Proposed 2000-1 Implementation Plan Changes

Technical Justification of K-Basin Sludge Changes to 2000-1 Implementation Plan

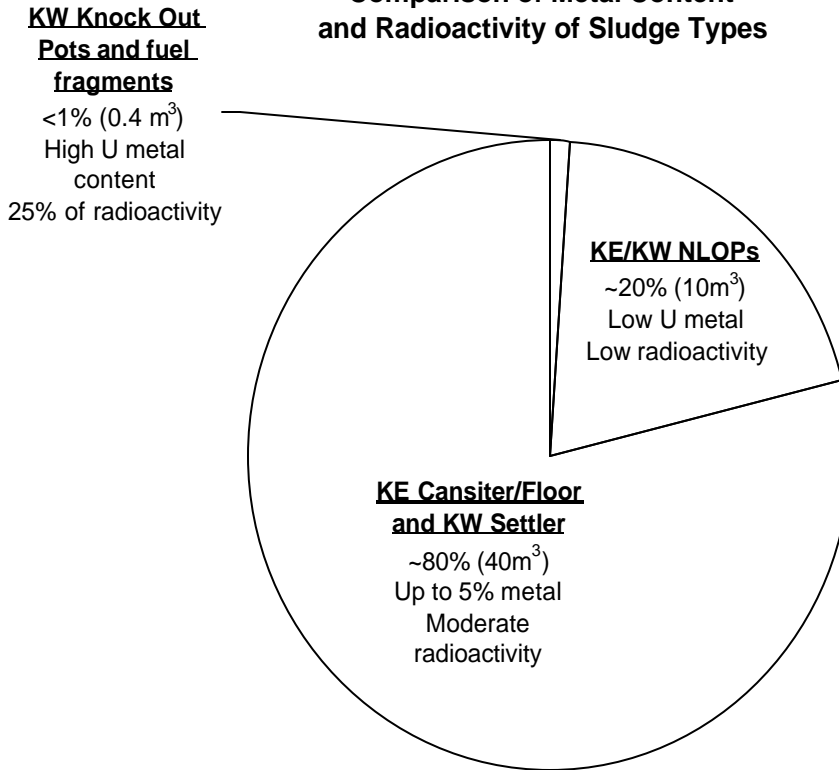
Commitment Statement: Complete removal and packaging of all sludge
IP Commitment Number: 120W
Due Date: April 2007⁷

⁷Previous revision due date: August 2004

K-East Containerization Schedule

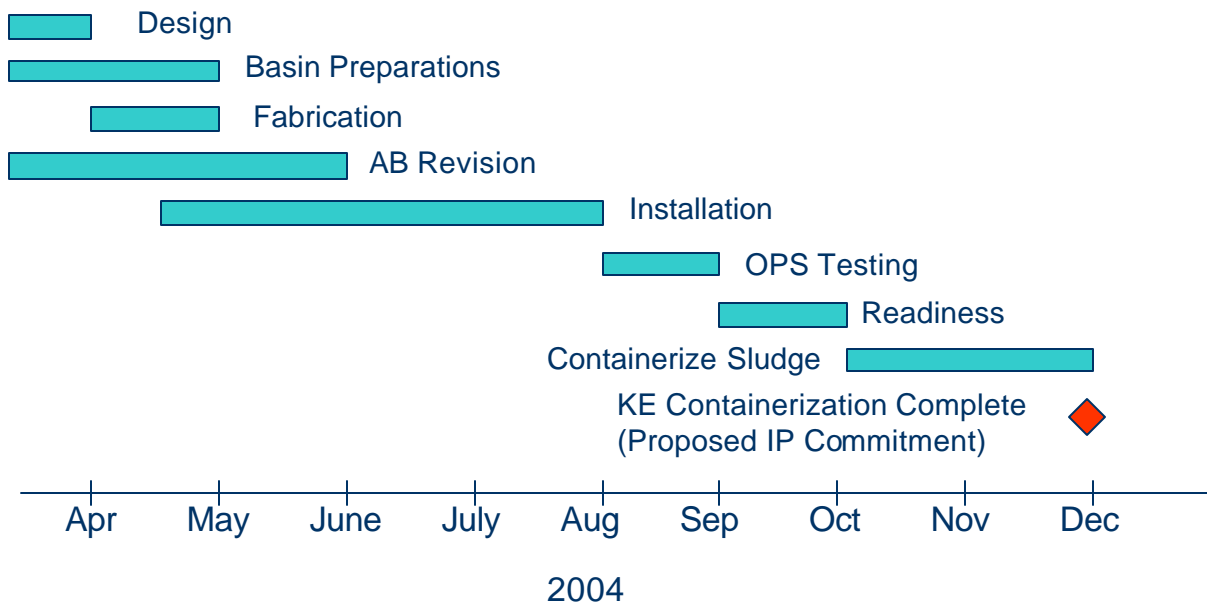
1. Construction of tanks in the basin that will have enough capacity for all of the sludge in K-East in accordance with approved design criteria.
2. Retrieving and consolidating approximately 37 m³ of sludge from the K-East Basin floor and pits. The existing sludge retrieval system would be used and is capable of pumping the sludge slurry from the basin floor at 60 gpm. One pump will feed 2 containers to achieve a proper settling velocity. A flocculent will be injected in the slurry stream to aid in particle settling via an in-line static mixer. Additionally, inclined tub settlers installed at the top of each container will aid in settling the sludge, keeping it in the tank, and minimizing it from adding turbidity to the basin water.

3. Screening out fuel scrap/debris greater than 0.25 inch (material less than 0.25 inches is considered sludge).
4. Retrieve any found fuel
5. Transfer fuel scrap and found fuel to the K-West Basin for processing and shipment to the Canister Storage Building for long term storage.

K-East to K-West Transfer Schedule

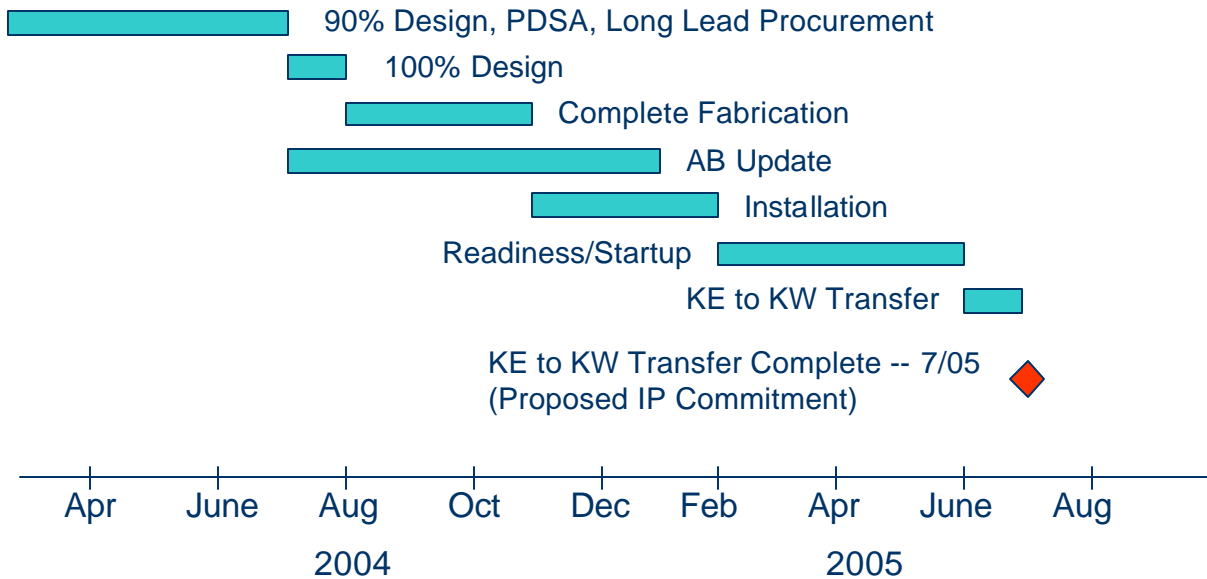
1. Design and construct hose-in-hose transfer system between K-East and K-West Basin.
 - The pumping system will use a proven design from the Tank Farm transfers. The double contained hoses will be provided with leak detection capabilities to warn of leakage and hose and fitting designs from the Tank Farm transfers will also be used. Sludge slurry (consisting of about 1 percent sludge) will be pumped over a distance of 2, 200 feet and will require 3 booster stations. A K-West water return pump will also be installed.

2. Design and construction of containers in K-West.
3. The containerized sludge in K-East will be pumped to the K-West Basin tanks.
 - The sludge will be pumped at a sufficient velocity to prevent particles from settling out along the length of the piping. Pumping will be done in batches and will be limited by allowable water level changes in the basins. Because of the considerable dilution, dose for workers will be minimized. When a sufficient amount of sludge slurry has been pumped from K-East to K-West, K-East basin water will be used to flush remaining sludge slurry from the piping. Water from K-West Basin will be pumped back to the K-East Basin to maintain water levels in accordance with operational and safety limits.

K-West Containerization Schedule

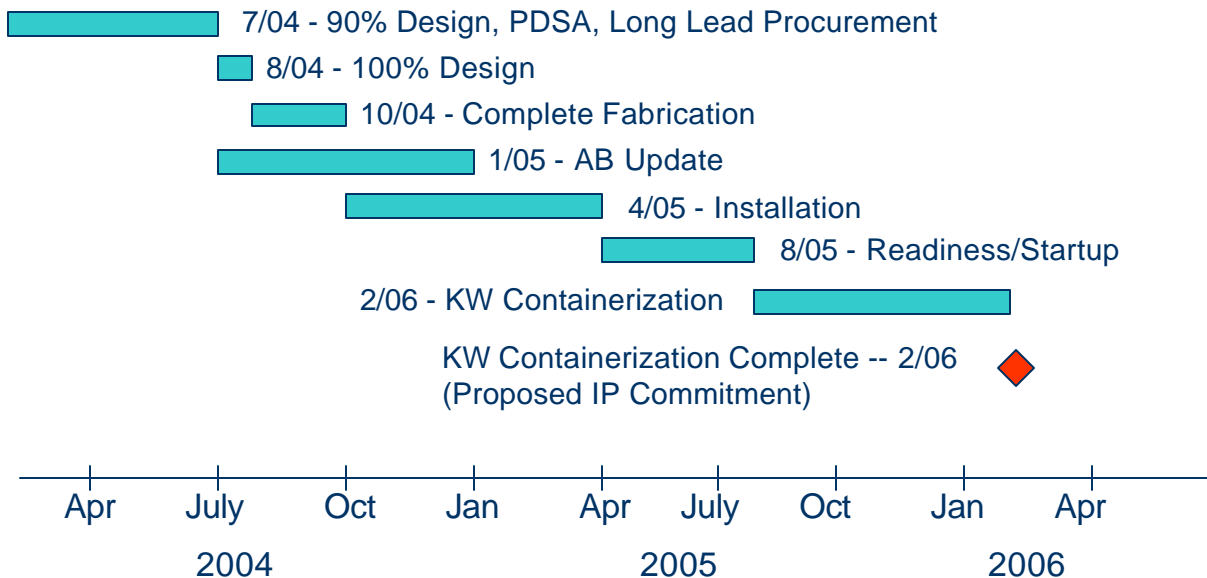
1. Retrieve and consolidate approximately 4.6 m³ of sludge from the K-West Basin floor and pits.
 - a. Retrieve sludge from the west bay, in the vicinity of fuel processing, into the IWTS.
 - b. Retrieve the balance of floor and pit sludge into the K-West containers.

K-West Sludge Removal and Treatment and Packaging Schedule

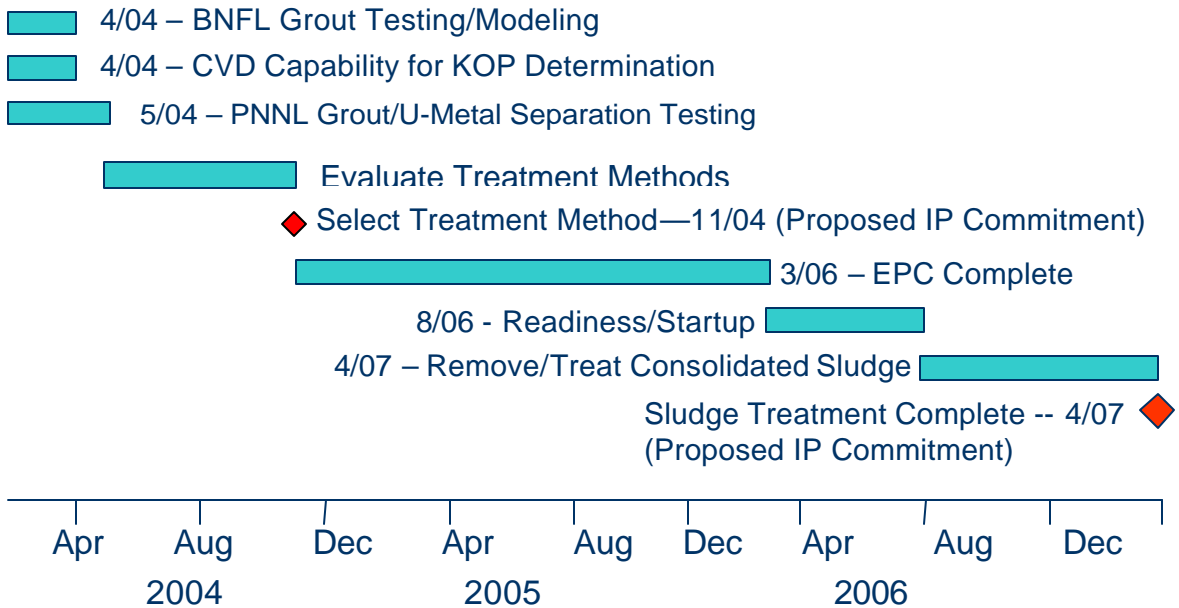
1. Install treatment and packaging equipment.
2. The sludge will be retrieved from consolidation tanks.
3. The sludge will be grouted to meet the draft RH TRU WIPP WAC.
4. Resultant RH TRU waste form will be placed in lead overpack drums
5. Shipped to the Central Waste Complex for interim storage awaiting certification and shipment to WIPP.
